VILLAGE OF LOMBARD
REQUEST FOR BOARD OF TRUSTEES ACTION

TITLE: PC-08-20: 3 Yorktown Shopping Center (Cole Taylor Bank)

**VILLAGE OF LOMBARD
INTER-DEVELOPMENTAL REVIEW GROUP REPORT**

PC 08-20, 3 Yorktown Shopping Center (Cole Taylor Bank): The petitioner requests the following variations from the Lombard Zoning Ordinance for landscaping requirements in certain portions of the property located within the B3PD Community Shopping District, Planned Development:

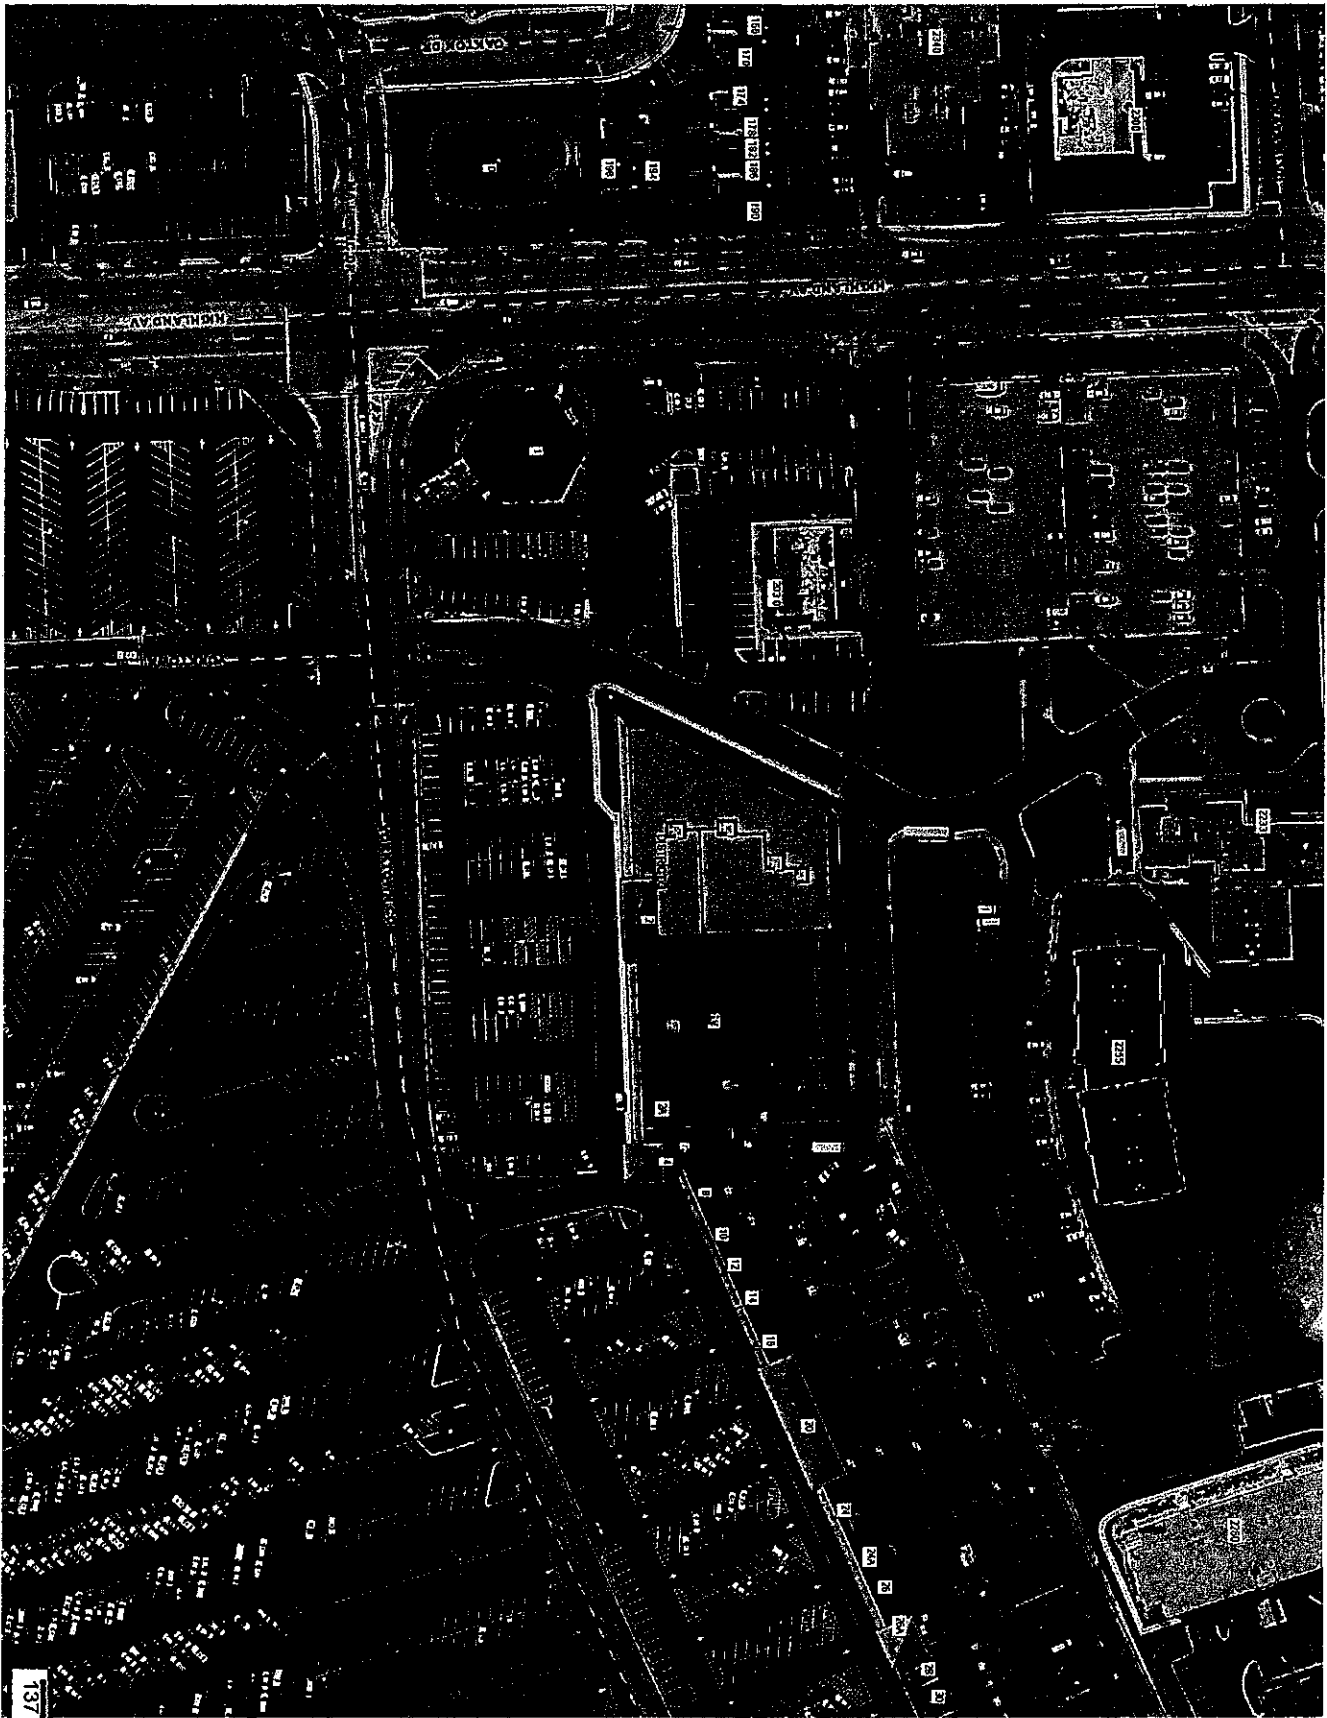
The property is unique in that the utility easement contains (2) ComEd lines, Nicor, Water, Sewer, & AT&T lines (see attached photo indicating existing utilities)

No the area in question is void of landscaping today our intentions are to provide lawn to be contiguous from the south lawn of the Parking garage.

No the utility easement is between our building and the parking garage to the north. The parking garage slopes to our property.

1. A minimum of one-third of the transitional landscape area along the north property line shall be planted with a combination of decorative ground cover and grasses, similar to that proposed along the eastern edge of the Cole Taylor Bank building. A final landscape plan shall be submitted to the Department of Community Development for review and approval.
